Serial No: 10/626,463

For: CONVEYOR TRACK DRIVE

RESPONSE TO OFFICE COMMUNICATION

FIG. 4

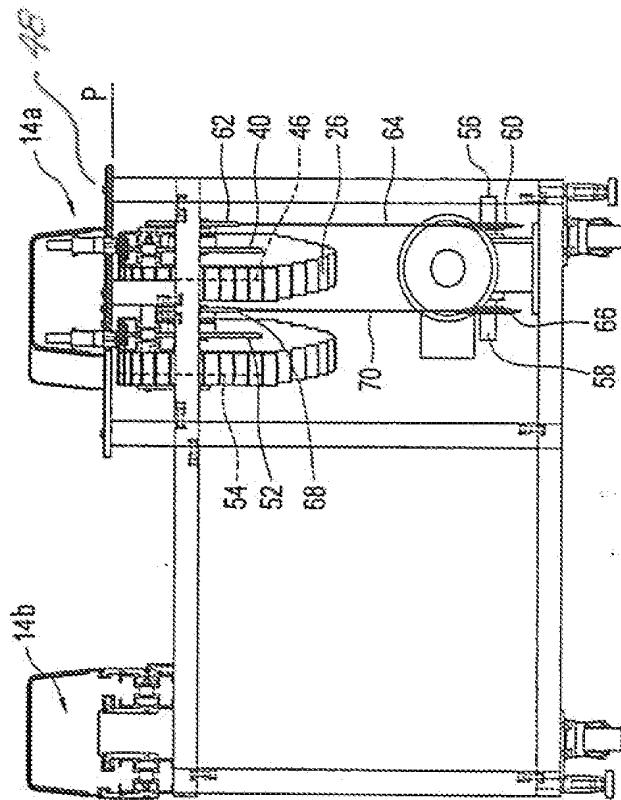
The slots 50 and 52 are indicated only at the far bottom of Figure(s) 5 at their straight portions. No attention is drawn to the transversely angled portions of the slots as being the member(s) that passively shifts the object(s) as the conveyor travels. [Office Action 01/04/2007, page 3]

This insertion, identifying sidewalls 50A and 50B of the slots is

the exact part of the disclosure that was missing. [Office Action 01/04/2007, page 3]

Because FIG. 5 is a top plan view, it is impossible to discern the depths of the sidewalls 50A and 50B in FIG. 5, as originally submitted. This same shortcoming is also apparent in FIG. 6, as originally submitted. FIG. 4, however, is an end elevational view of the drive mechanism, showing the

upstream end of the device. According to the specification, item 20 is a specimen carrier [page 6, line 14 of the specification], item 26 is a table top chain [page 6, line 18 of the specification], item 26a is the first segment of chain 26 [page 7, line 21 of the specification], item 26b is the second segment of chain 26 [page 8, lines 11 and 20 of the specification], item 48 is a carrier guide plate [page 8, line 4 of the specification], and item 50 is a slot formed in the guide plate [page 8, line 7 of the specification]. Upon viewing FIG. 4, as originally filed, it can be seen that the carrier guide plate, which is not identified by the reference numeral 48 but is highlighted in red ink (see Exhibit I-ROC), forms a boundary circumscribing the slot 50. While items 50A and 50B constitute the sidewalls of the slot 50, in reality, the sidewalls of the slot 50 are formed by the edges of the carrier guide plate 48. The edges of the carrier guide plate 48 were disclosed in the original drawing of FIG. 4. Moreover, because the carrier guide plate 48 is made of a three-dimensional material, a slot formed through the major surfaces of the carrier guide plate 48 will have edges circumscribing the slot formed therethrough. Accordingly, the sidewalls 50A and 50B are formed by the edges of the carrier guide plate 48, are disclosed in original FIG. 4, and, consequently, the sidewalls 50A and 50B do not constitute new matter. In view of the foregoing reasons, the sidewalls 50A and 50B of the slot 50 are disclosed in the drawings, i.e., FIG. 4, as originally filed, and consequently, the sidewalls 50A and 50B are not new matter. Accordingly, the rejection based on new matter should be withdrawn.
